PROJECT REVIEW COMMITTEE - CITY OF WILDWOOD
PRC Chairperson – Melanie Strickland

Agenda
Regular Meeting
July 8, 2025 10:00 AM
Commission Conference Room 124
100 N Main Street

- 1. A25-1833 - PLAT - Preston Place Business Park Final Plat
Parcel D17-131, D17-134, D17-135, D17-137**

2. **A25-0583 UF Health Oxford Freestanding Emergency Department
Portion of Parcel D17-134**

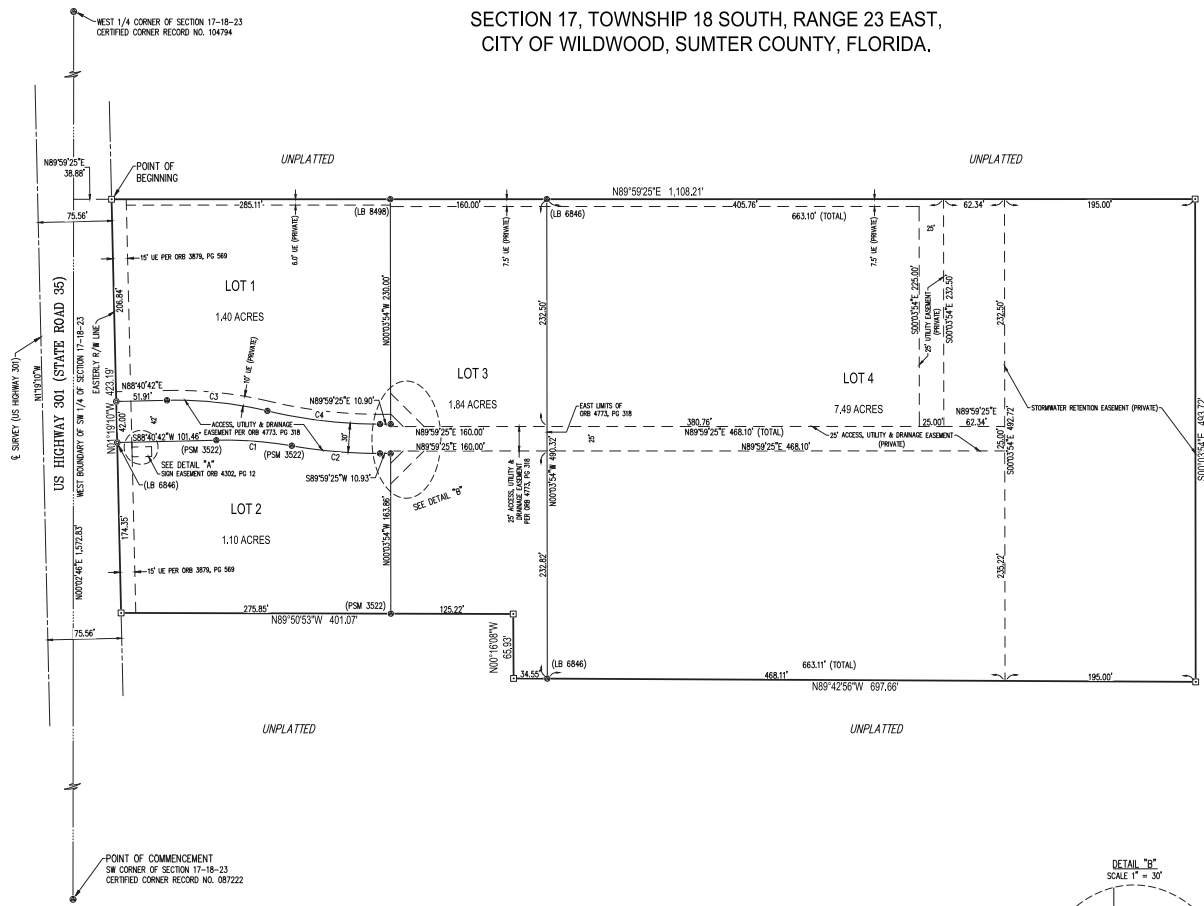
1. Provide a copy of the executed Mortgagees' Joinder and Consent to Dedication documents referenced in note # 10.
2. Please advise why the following access, utility and drainage easement for ORB 4773, Page 318 that is noted on sheet 2 of the plat plan but is not included in the Title Opinion document.

1. The title opinion is in compliance.
2. Sheet 1 of 2: Is in compliance with F.S. Chapter 177.
3. Sheet 2 of 2: Dimensions in Detail “B” are not coincident with those shown on the Plat.

SHEET NO. C1.1

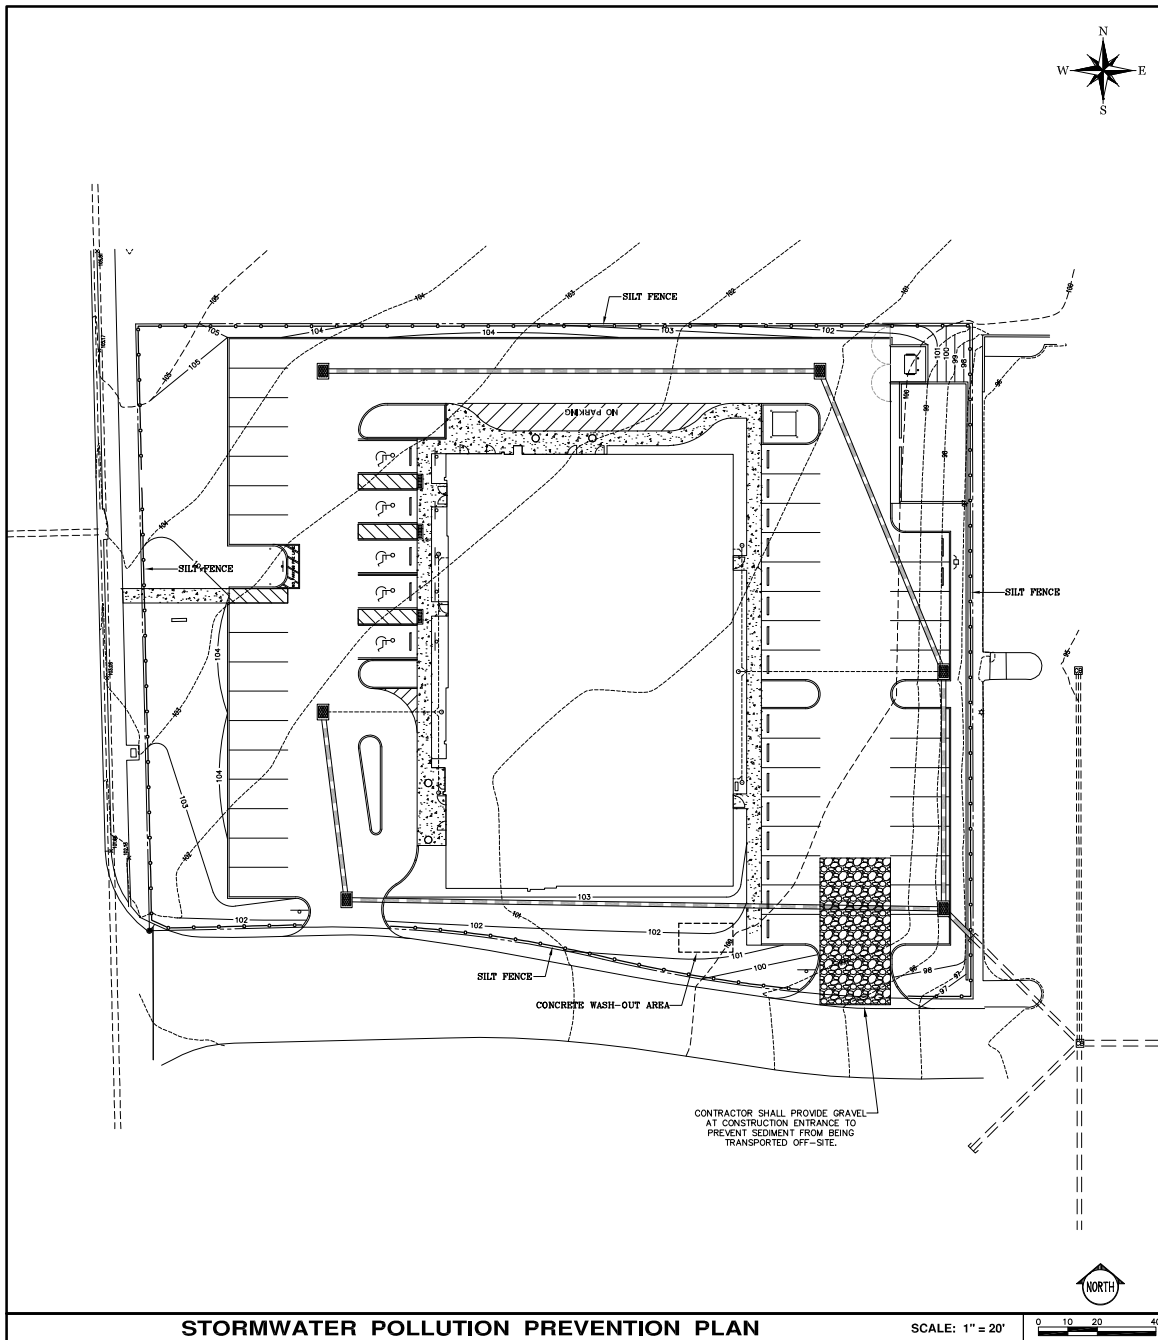
1. Please add the applicant's phone number to the cover sheet of the site plan.
 - A. The Applicant's phone number has been added to the cover sheet.
 - I. Not satisfied; the applicant information was updated, but the phone number was not included.

- a. **Applicant phone number added to Sheet C1.1.**
 - i. **Satisfied.**
2. Please provide an authorized agent form from the owner to the applicant (Boldt c/o Faeq Hussain).

SCALE: 1"=20'
 DATE: 3.28.2025
 CAD FILE: 036-UT
 JOB NUMBER: KFC-WILDMOOD
 SHEET: C06

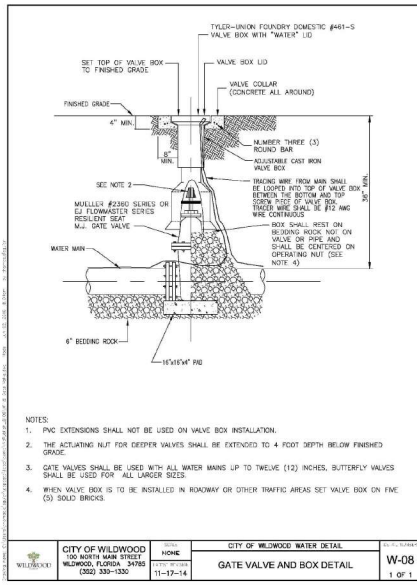
1. Sheet C-06, Utility Plan: Label the two way clean out at “End of City Maintenance” as a “Sample Point”. Please revise the sheet.
2. Sheet C-08, Civil Details: Update/replace all water/sewer detail sheets to the current version dated 2024. Please revise the sheet.
